## SHOP DOPE

No. 376 (Supersedes No. 356, which should be destroyed)

TRANSMISSION MAINSHAFT SECOND AND THIRD GEARS  
(This information applies to Models KH, KHK, and KHRM)

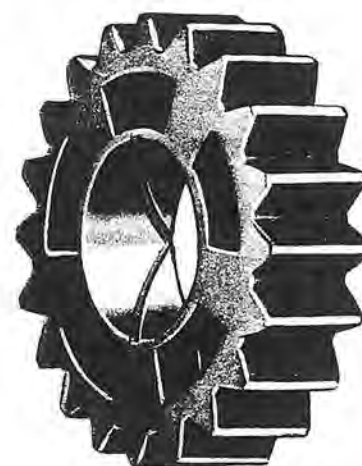
Illustration shows new design M/S 2nd and M/S 3rd gears having 5 driving lugs and slots instead of 4. These new gears have been used in all 1956 KH transmissions, and from above date will be the only M/S 2nd and M/S 3rd gears supplied for servicing 1954-1955 KH transmissions, as follows:

- 1 35296-56 M/S 2nd gear, 23 teeth-5 lugs (replaces 35297-54A, 4 lugs)
- 1 35305-56 M/S 3rd gear, 20 teeth-5 slots (replaces 35304-54, 4 slots)
- 1 35337-56 M/S 3rd gear retaining ring (replaces 35337-52)
- 1 35364-56 M/S 3rd gear washer (replaces 35364-52)

These new gears, being much stronger than the design used in earlier transmissions, are to be used exclusively for future servicing of all KH transmissions. In other words, when either 35297-54A, 4 lug M/S 2nd gear, or 35304-54, 4 slot M/S 3rd gear requires replacement in a 1954 or 1955 KH transmission, gear set 35297-54B is to be installed.
